**Wichita-Sedgwick County
Metropolitan Area
Planning Department**

September 30, 2024

RE: CUP2024-00032 – Administrative Adjustment in the City to the Mediterranean Plaza Commercial CUP DP-111 to permit Animal Care, Limited on Parcel 1, on property zoned LC Limited Commercial District; generally located on the northeast corner of North Rock Road and East 29th Street North (3000 N. Rock Road).

COMMUNITY UNIT PLAN - D.P. - 111

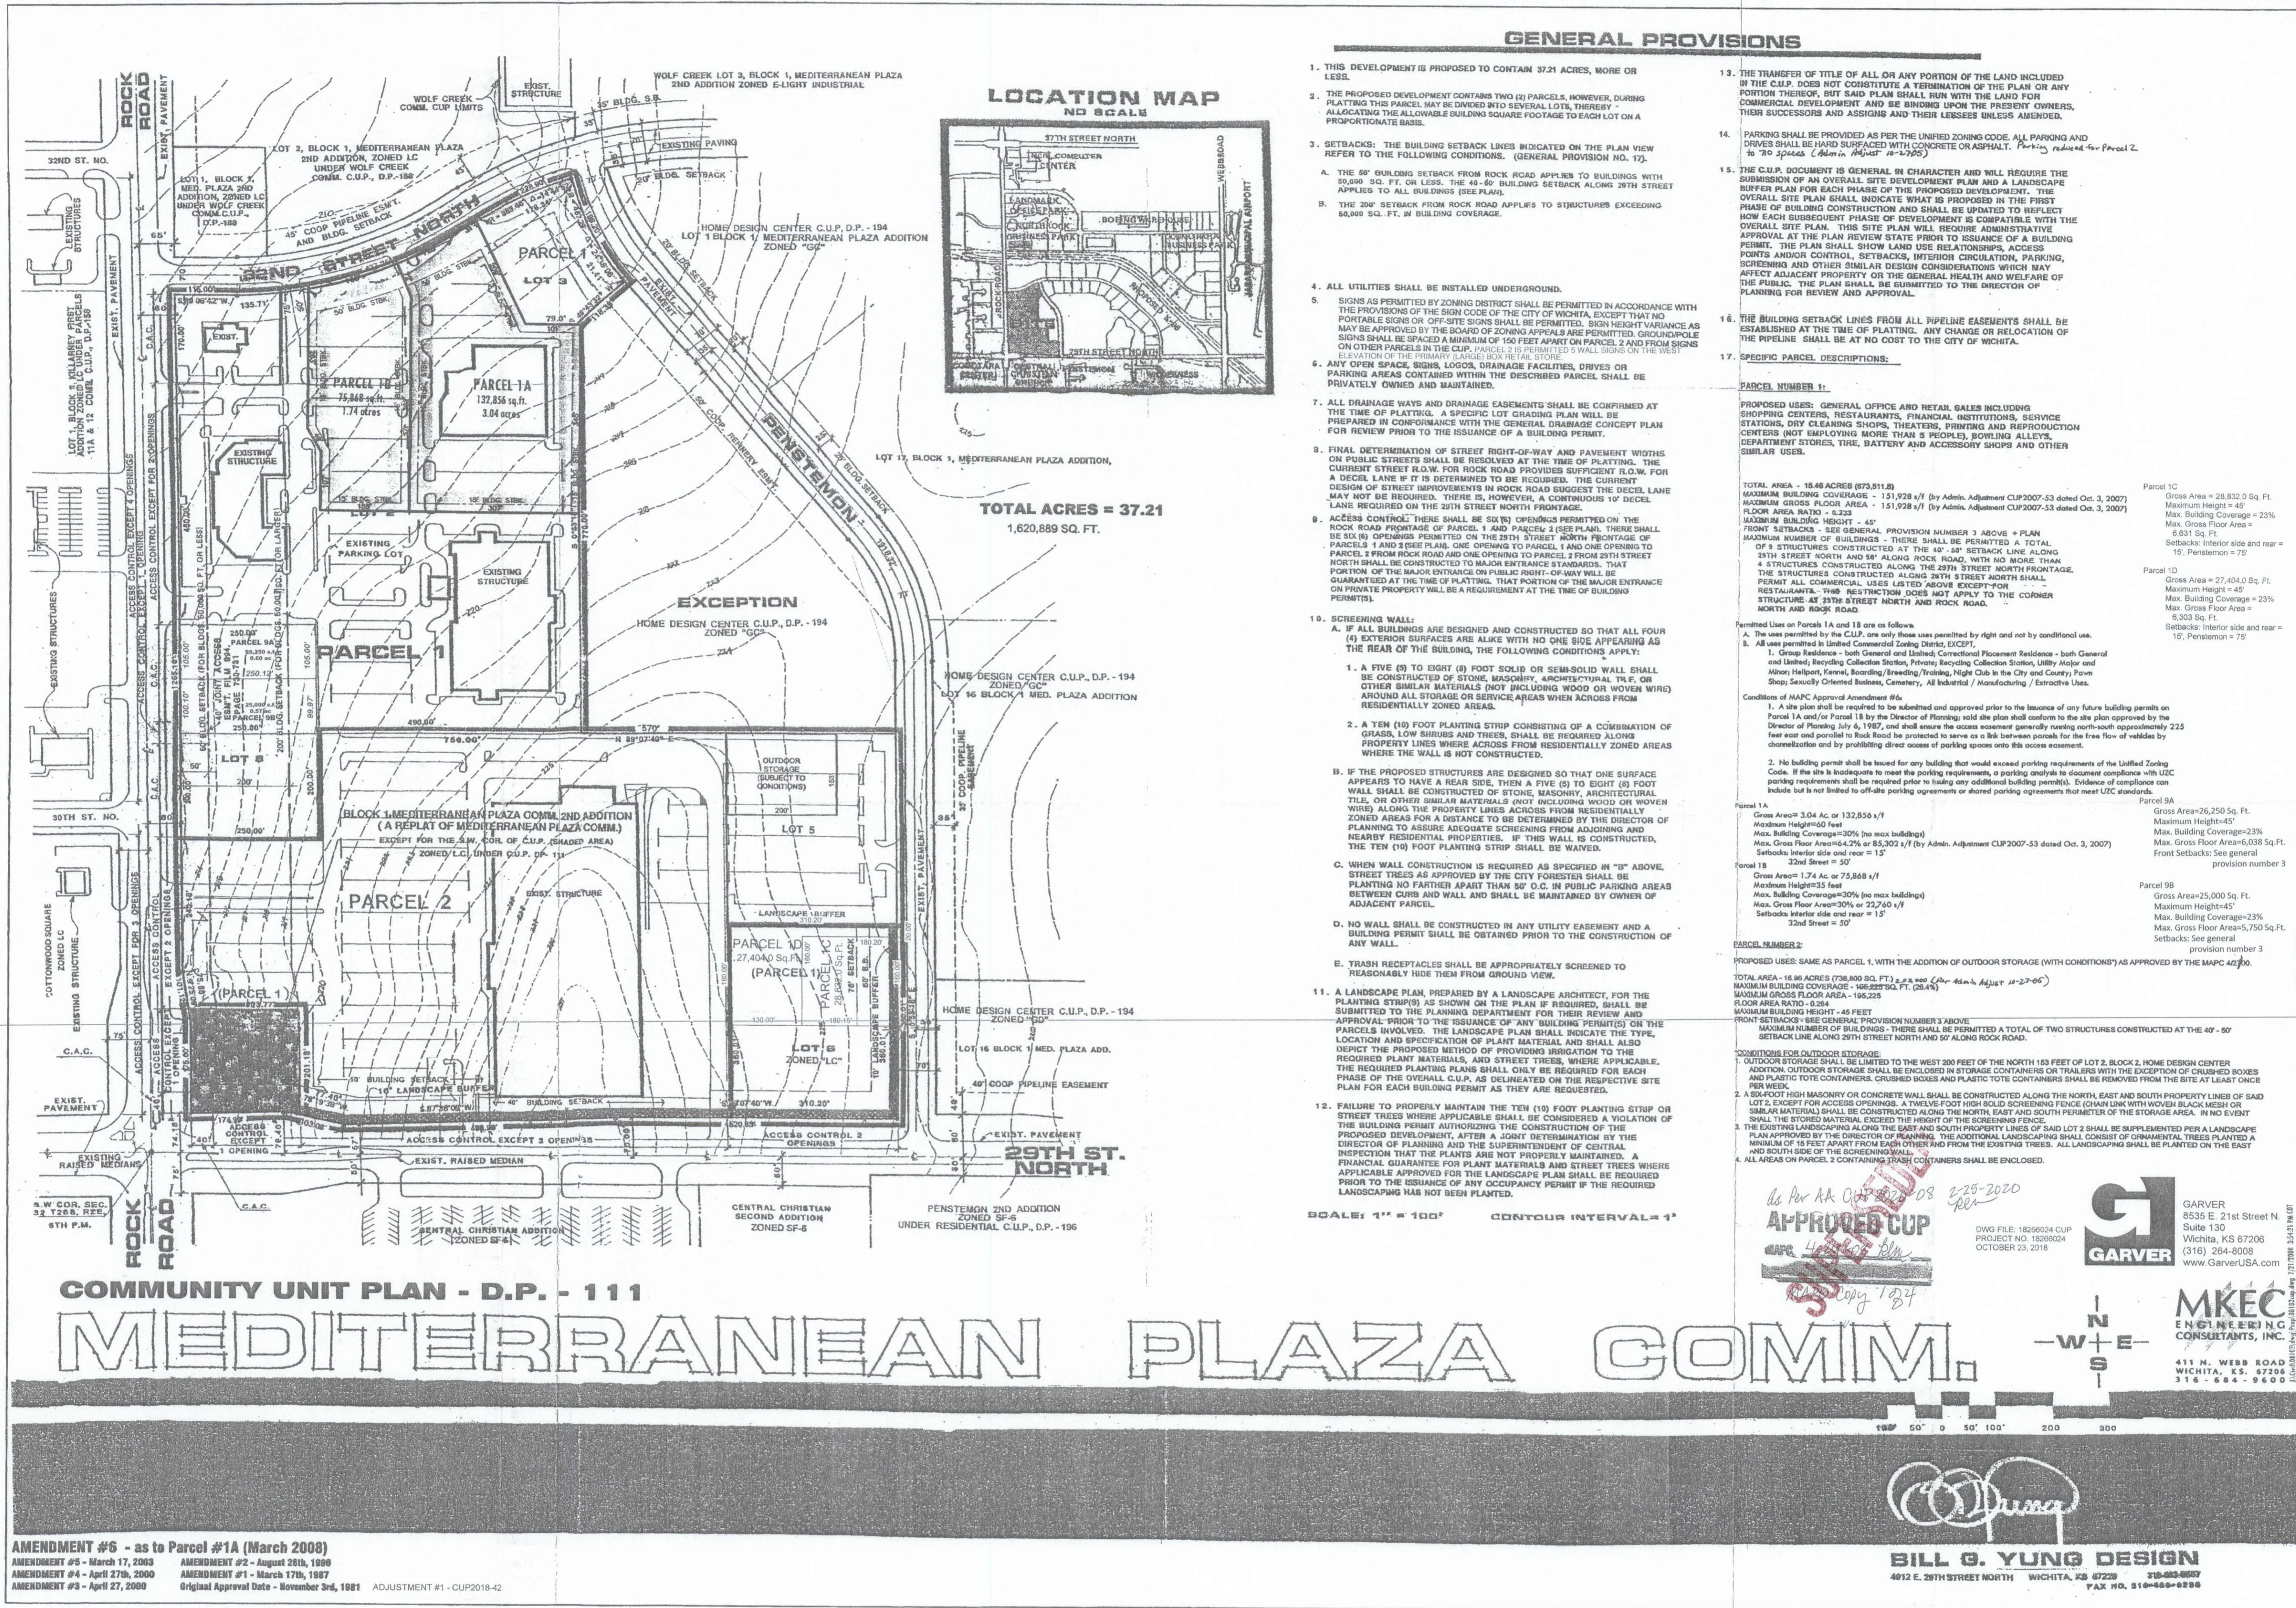
Proposed Uses: General Office and Retail Sales including Shopping Centers; Restaurants; Financial Institutions; Service Stations; Dry Cleaning Shops; Theaters; Printing and Reproduction Centers (not employing more than 5 people); Bowling Alleys; Department Stores; Tire, Battery, and Accessory Shops; **Animal Care, Limited**; and other similar uses.

1. Boarding of any animal shall be accessory to Animal Care, Limited and is only permitted for animals while they are receiving care at the facility.
